***3 Volt Intel® Advanced Boot
Block Flash Memory
28F004/400/008/800/
016/160/320/640B3 (x8/x16)***

Specification Update

April 2002

Order Number: 297948-012

2. Invalid Read Durations for CE# High Pulse Width

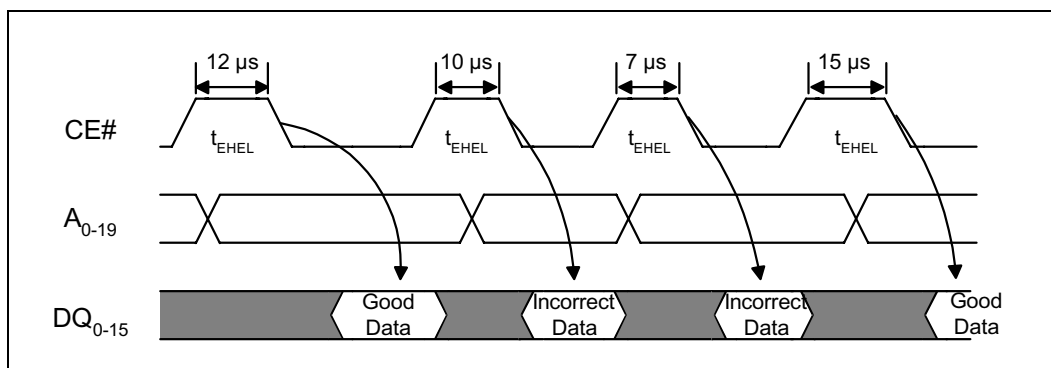
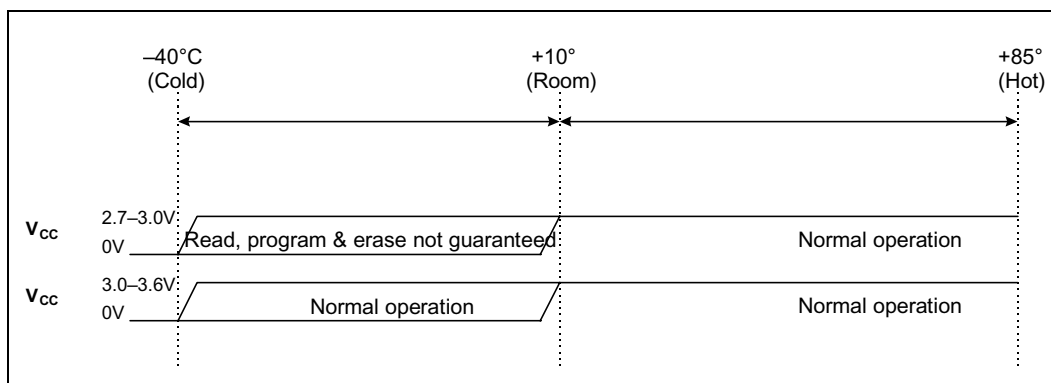
Problem: During consecutive read operations, CE# may be left low or toggled as desired. If CE# is toggled high (see diagram below) for 4 μ s–11 μ s between read operations, subsequent reads will return incorrect data.

Implication: If CE# is not toggled between consecutive reads, there is no impact. Any application that toggles CE# between read operations will be affected if the CE# high pulse width is within the nonfunctional range, i.e., 4 μ s $\leq t_{\text{EHEL}} \leq 11 \mu$ s.

Workaround: Either of the following actions will prevent this erratum:

1. Do not toggle CE# between consecutive read operations
2. Insure t_{EHEL} is less than 4 μ s or greater than 11 μ s

5. Maximum I_{CCD} Change

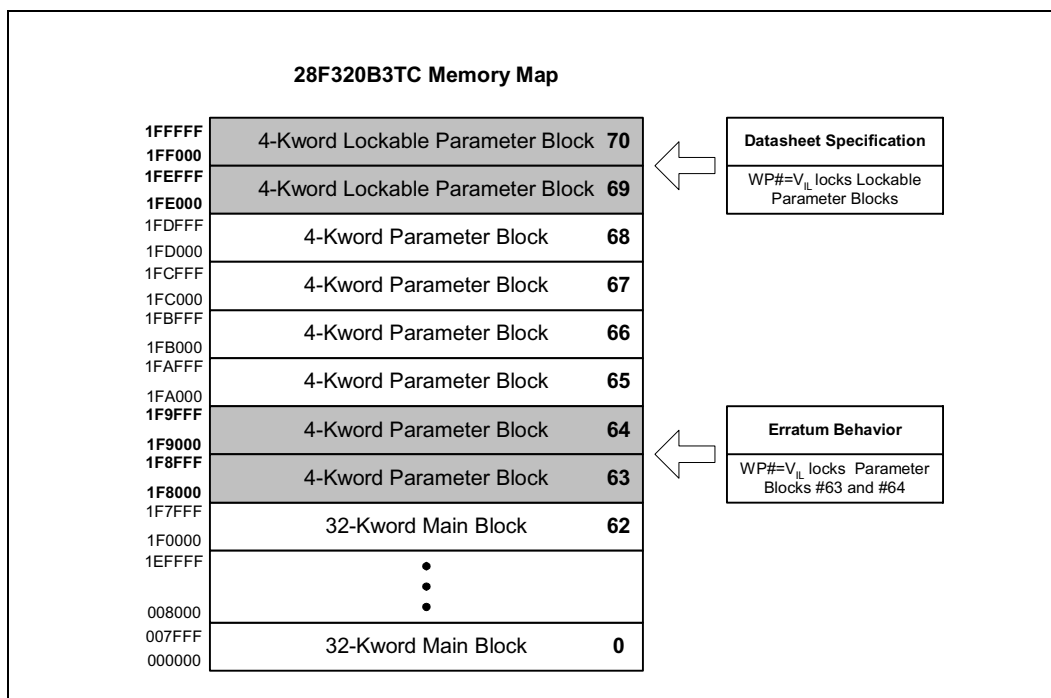
Problem: The maximum I_{CCD} increases from 20 μ A to 25 μ A. The following in the revised I_{CCD} specification:

NOTE: Since each column lists specifications for a different V_{CC} and V_{CCQ} voltage range combination, the test conditions $V_{CC} \text{ Max}$, $V_{CCQ} \text{ Max}$, $V_{CC} \text{ Min}$, and $V_{CCQ} \text{ Min}$ refer to the maximum or minimum V_{CC} or V_{CCQ} voltage listed at the top of each column.

Implication: The maximum I_{CCD} is specified under worst case conditions only ($V_{CC} = 3.6$ V, temperature = +85 °C). The typical I_{CCD} specification should be used to determine I_{CCD} current draw under typical conditions ($V_{CC} = 3.3$ V, temperature = +25 °C). The typical I_{CCD} specification has not changed.

7. 28F320B3xC Reset Failure

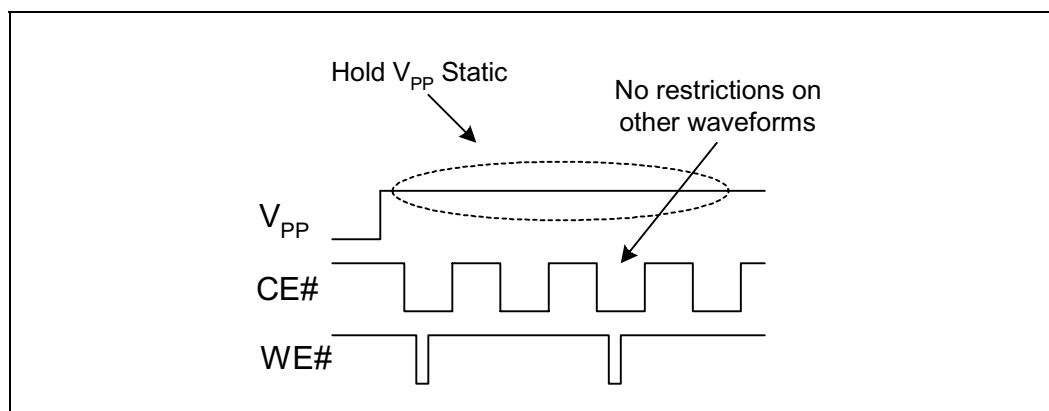
Problem: The 0.18 μ m 28F320B3xC devices can unintentionally reset under certain conditions where V_{PP} toggles.

Implication: When the reset occurs, any command being executed is interrupted and the flash switches to read array mode.

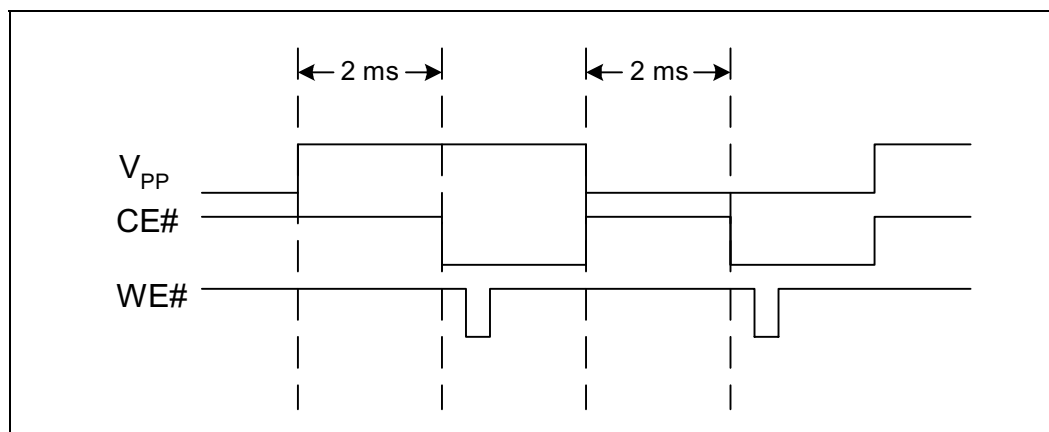
3) Set V_{PP} to a static high or static low level as shown here; and

4) Wait 2 ms after a V_{PP} transition to access the flash device as shown here.

Figure 1. Workaround Placement

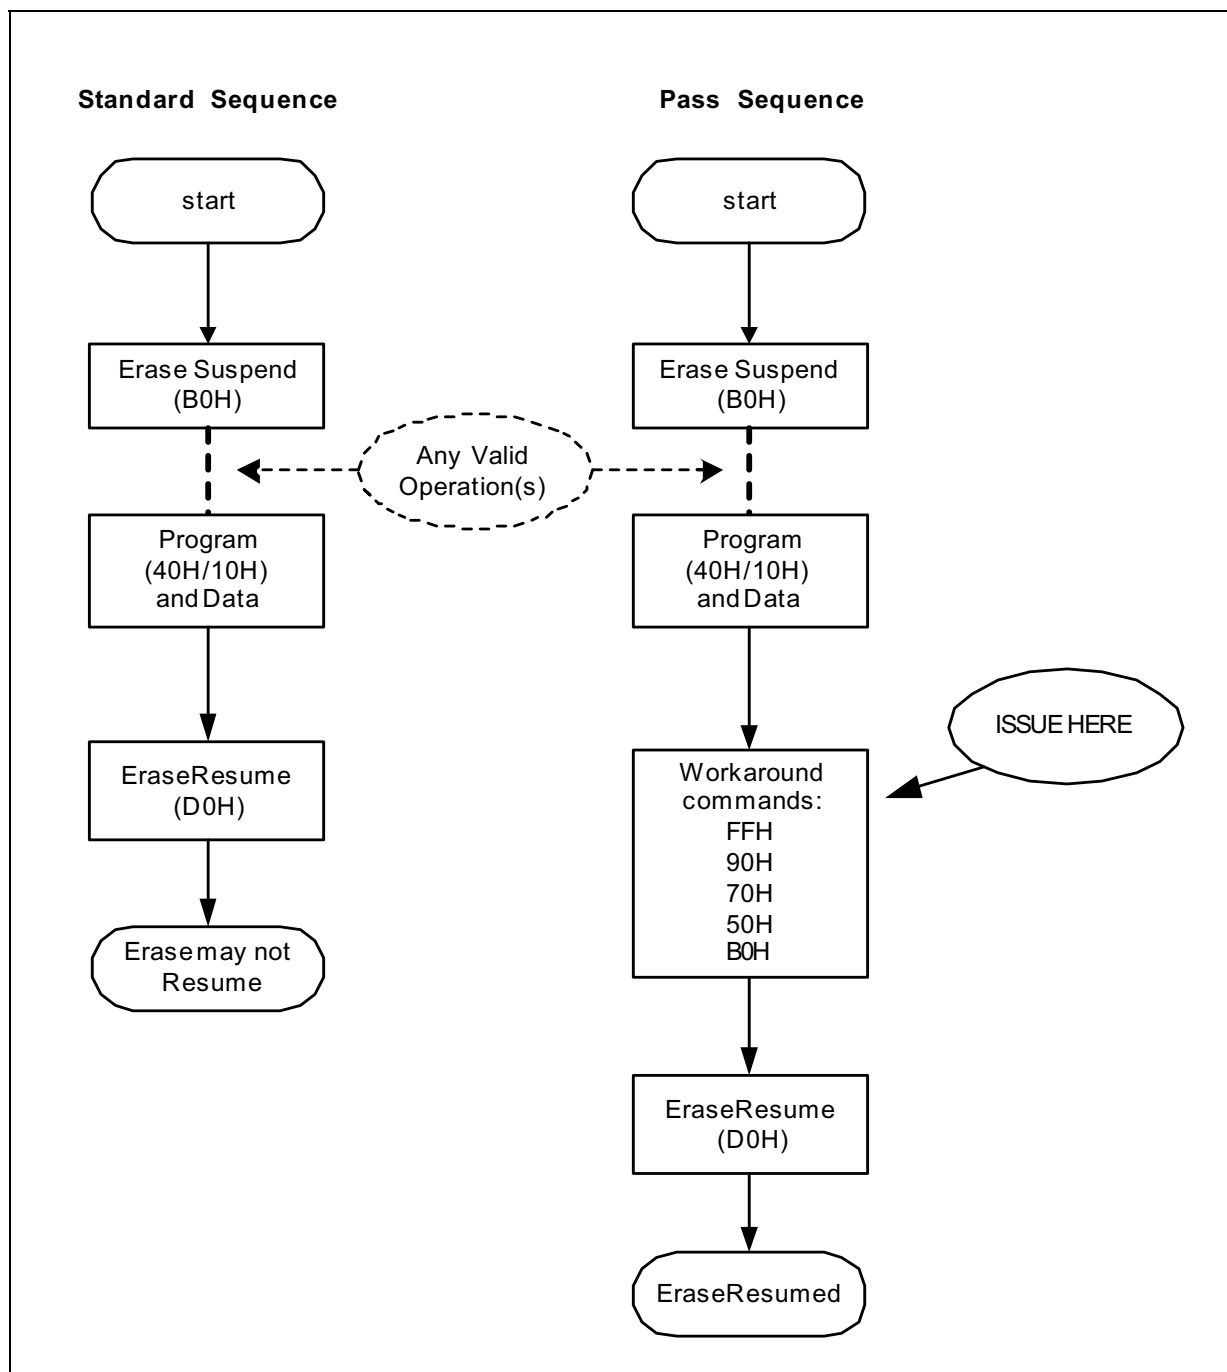
Problem: On the 0.18 μ m 28F160B3xC device, a design anomaly was discovered. During an Erase-Suspend operation, if the Program (40H/10H) sequence is executed, under limited conditions the proceeding Erase Resume command (D0H) may not actually resume the device. No customers have reported failures in product applications. Customers who use any version of FDI (Intel Flash Data Integrator) software will not see this issue. If the Read Array command is issued prior to the Erase Resume command, users will not see the issue (typical in XIP applications).

Implication: The Resume Command (D0H) may be ignored by the device and will not correctly resume. The device will appear to remain in suspend (via status register). After a reset of the flash device the status register will clear. This failure has been recreated in a lab environment only.

1. If FDI (Intel Flash Data Integrator) software is used, users will not see the issue.
2. During an Erase-Suspend (B0H), user must issue any of the following commands listed in Table-1 after issuing the Program (40H/10H) and data sequence but before issuing the Erase-Resume (D0H) command.
